Date: 05 December 2023
Our Reference: J001675
Your Reference: DA / 4677:AD2023 / 0004947

Site Address:	81 Savage Street, Cooktown 4895
Property Description:	Lot 212 on C17915
Method of Distribution:	Email (mail@cook.qld.gov.au)
Correspondence Subject:	Response to Information Request Pursuant to s.13 of the Development Assessment Rules (Version 1.3)

INFORMATION REQUEST RESPONSE

Extract 1 - Amended - Proposed Site Section 02 (DA08 - Issue TP5)
Source - i2c Architects

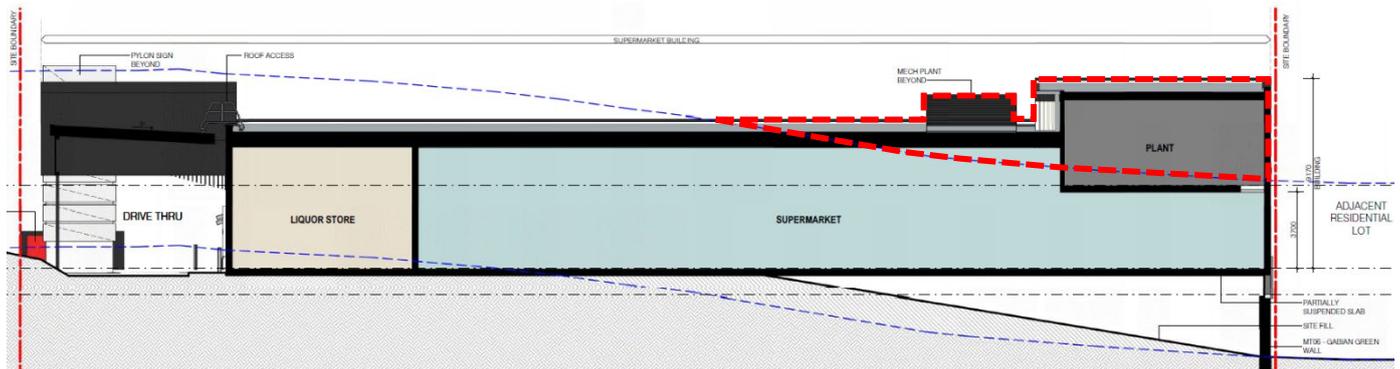
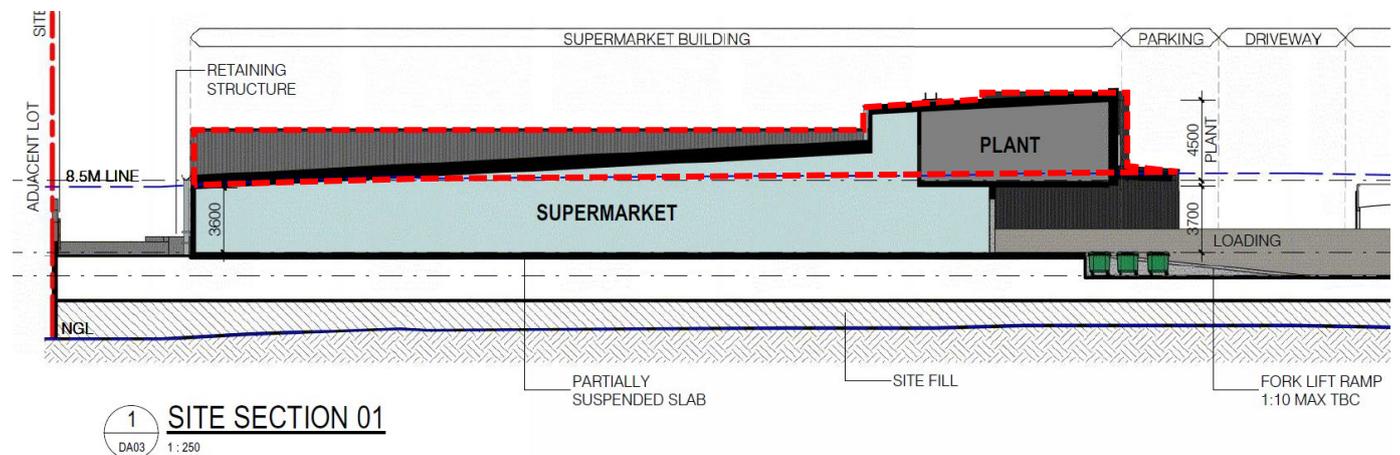
3. The proposed development exceeds the maximum height requirement of 8.5m (P01 - Medium density residential zone code) and involves large expanses of built form with an extensive car parking area. Further information is required to demonstrate that the scale and height of buildings is consistent with a residential built form. It is noted that Appendix G identifies that the development complies with P01 however this has been insufficiently justified.

- It is acknowledged that the proposal does not involve residential development, however, the proposed built form has been carefully designed and refined in response to the information request to ensure the development positively contributes to a pleasant environment, establishing a high level of amenity for people accessing and passing by the site. This has been achieved through built form design, landscaping and appropriate boundary setbacks.
- The development involves a scale (gross floor area and site cover) which is consistent and compatible with a medium density scale type of development. Specifically, the proposal involves:

- A gross floor area of 2,272m² which equates to 18.6% of the site area (12,198m²); and
 - A site cover of 2,977m² which equates to 24.4% of the site area (12,198m²).
- The proposed development has been designed in response to the slope of the site. The proposal is largely one (1) storey and predominantly under 8.5m above ground level which aligns with the requirements of acceptable outcome A01 of the zone code.
 - The extent of the second storey is limited to the mezzanine plant room. The extent of non compliance with acceptable outcome A01 of the zone code in terms of metres above ground level, is limited to the portion of the built form highlighted within **Extract 1** and **Extract 2**.

- As outlined within the Town Planning Report, Cooktown Hardware is located on the adjoining site to the north west (48 Charlotte Street, Cooktown) and features a building height of 9.185m above ground level which is consistent and comparable to the maximum building height associated with this development application.
- The proposal involves 2,657m² of landscaping across the site which equates to 22% of the site area (12,140m²), ensuring a high standard of amenity is achieved across the site.

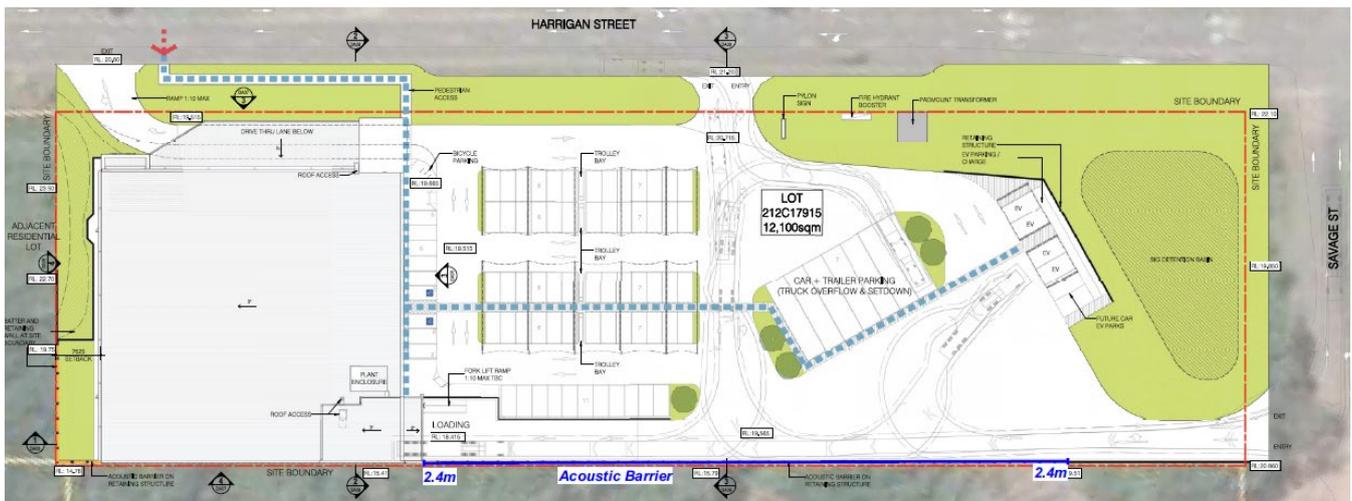
The site directly adjoins Low density residential zoned land on its western boundary. There are significant interface issues between the proposed shopping centre and the adjoining residential property relating to potential impacts on amenity. It is noted that the loading area and plant room directly adjoin the western boundary of the site. The application material identifies that an acoustic barrier is proposed to be constructed, however the design of the proposed acoustic barrier is not supported by an acoustic report.

11. Given the proximity of the site to noise-sensitive development {residential uses}, an acoustic report prepared by a suitably qualified person is required to address potential noise impacts on residential amenity.

- All roof top mechanical plant to be acoustically screened.
- Acoustic screening to full perimeter of condenser deck area.
- Further investigations need to be undertaken to determine the final acoustic design features for the supermarket plant room during the detailed design phase, however, MWA Environmental recommend the following:

- The wall and roof component should achieve an Rw 40+.
 - The plant room to be lined with perforated metal sheeting with insulation material internally.

(a) Example A, Western Boundary on Section 3, Drawing DA08.

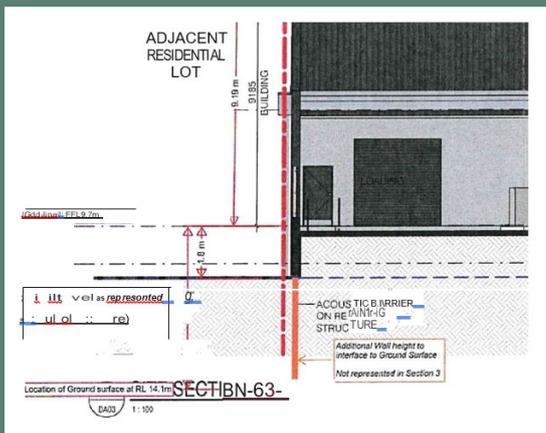
Section 3 on Drawing DADS does not appear to represent the natural surface and resulting level difference correctly (refer extract below).

The existing surface is represented as being only 1.8m below the FFL line of 19.7m. That is, the natural surface level at the Lot boundary on drawing DA08 Section 3 is measured as approximately RL17.9m.

However, the spot level shown on drawing DA03 near Section 3 is nominated as RL14.1. This represents a difference of approximately 2.8m between the represented surface and the actual surface.

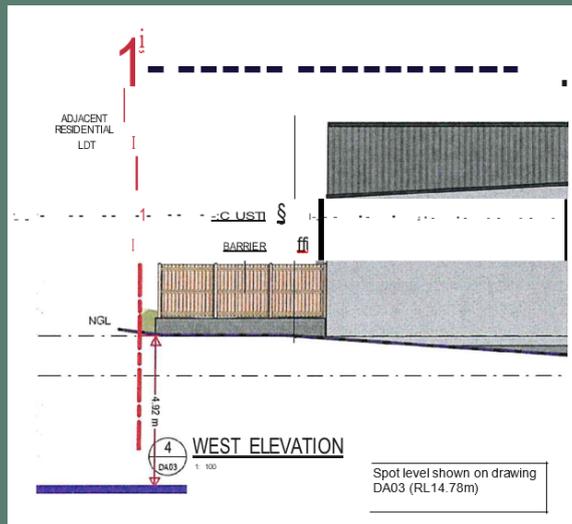
The spot level shown on drawing DA03 at the corner of northern and western Lot boundaries is RL14.78. This level has been verified against the site contours in the Bulk Earthworks design. However, there is an inconsistency between this level and the existing surface level (and profile) represented in the West Elevation shown on drawing DA07.

The existing surface level at the Lot boundary on drawing DA07 West Elevation section is shown to be coincident with or above the level of the FFL for the building, RL19.7m.

Given the building has minimal setback to the western boundary, the west elevation should reflect the levels along the western boundary. The spot level of RL14.78, verified from the Bulk Earthworks design, represents a difference of almost 5m from the existing ground level shown.

Extract 15 - Amended - Proposed Site Section 02 (DA08 - Issue TP5)
Source - i2c Architects

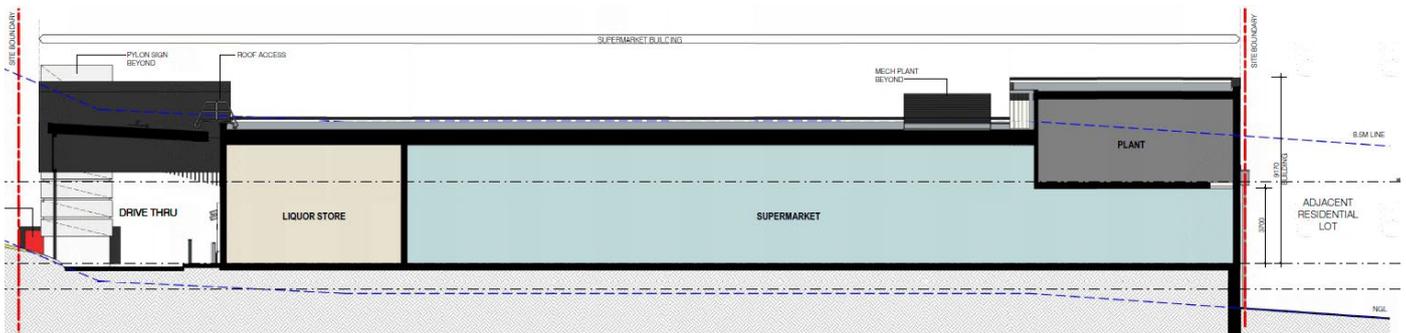
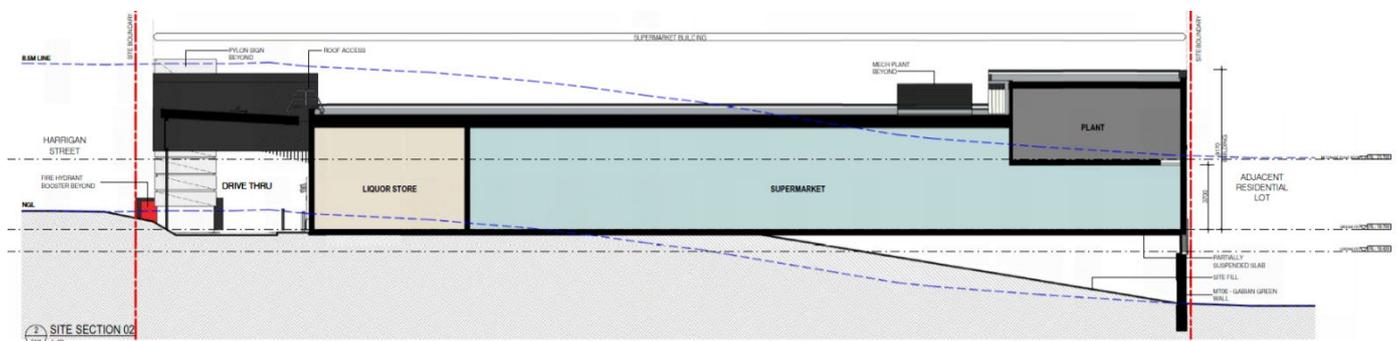
13. Provide revised drawings that address the apparent discrepancies with the existing ground surface level shown on the elevations and sections. The updated detail must also correct the building height

line shown and ensure that the plans accurately represent the height above the existing ground level.

The proposal plans submitted in support of the development application have been refined based on the information contained within the Detail Survey prepared by Brazier Motti (**Attachment 8**). As demonstrated within **Extract 15**, the natural ground level from the Detail Survey has been adopted within the Amended Proposal Plans (**Attachment 2**).

Extract 16 - Amended - Proposed Elevations (DA07 - Issue TP5)
Source - i2c Architects

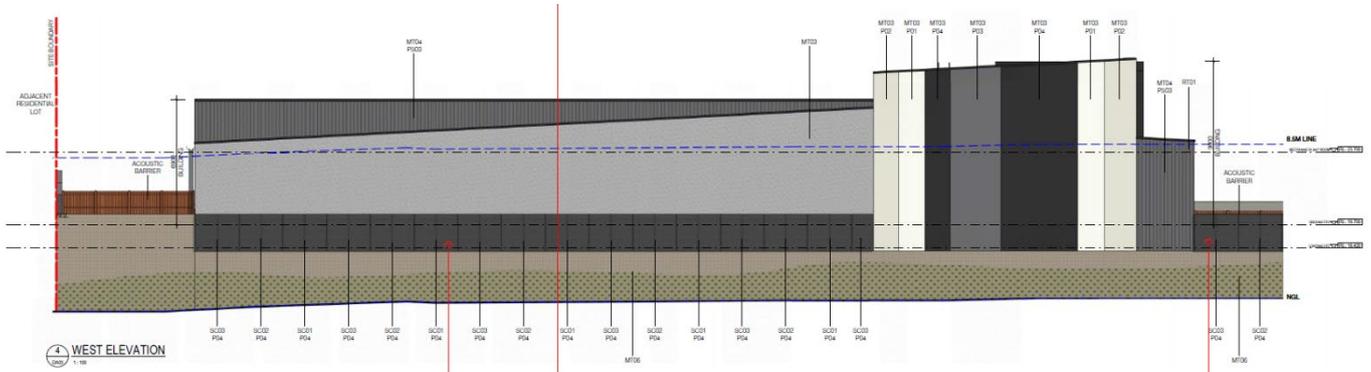
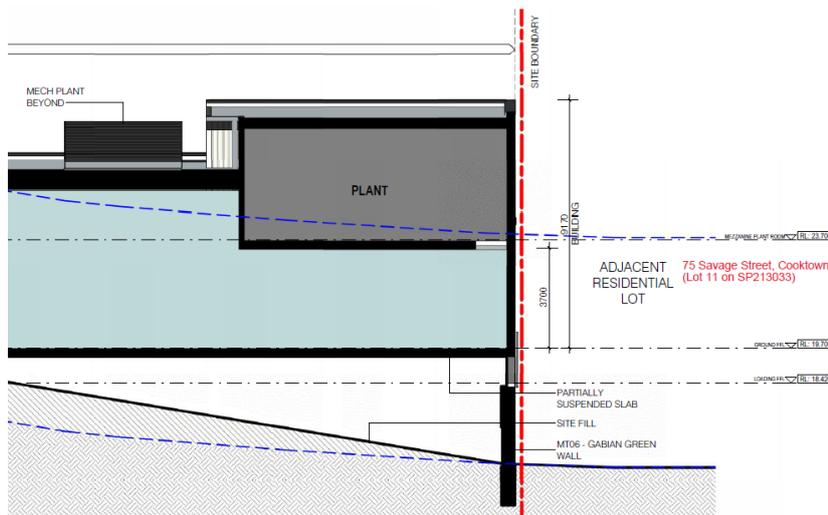
14. A plan is required that clearly and accurately depicts the works required at the interface of the western boundary. Provide dimensioned plans including the offsets between Lot boundaries and proposed retaining walls, and the top and bottom wall heights proposed for retaining walls. This is a key consideration in determining the potential impacts of the development on the adjoining residential amenity.

Extract 16 and **Extract 17** provide a visual representation of the boundary interface between the subject site (81 Savage Street, Cooktown - Lot 212 on C17915) and the adjoining lot to the west, being 75 Savage Street, Cooktown (Lot 11 on SP213033).

Specifically, **Extract 16** shows the development as viewed from the adjoining site to the west (75 Savage Street, Cooktown (Lot 11 on SP213033) and **Extract 17** provides a section through the common boundary, demonstrating the change in topography.
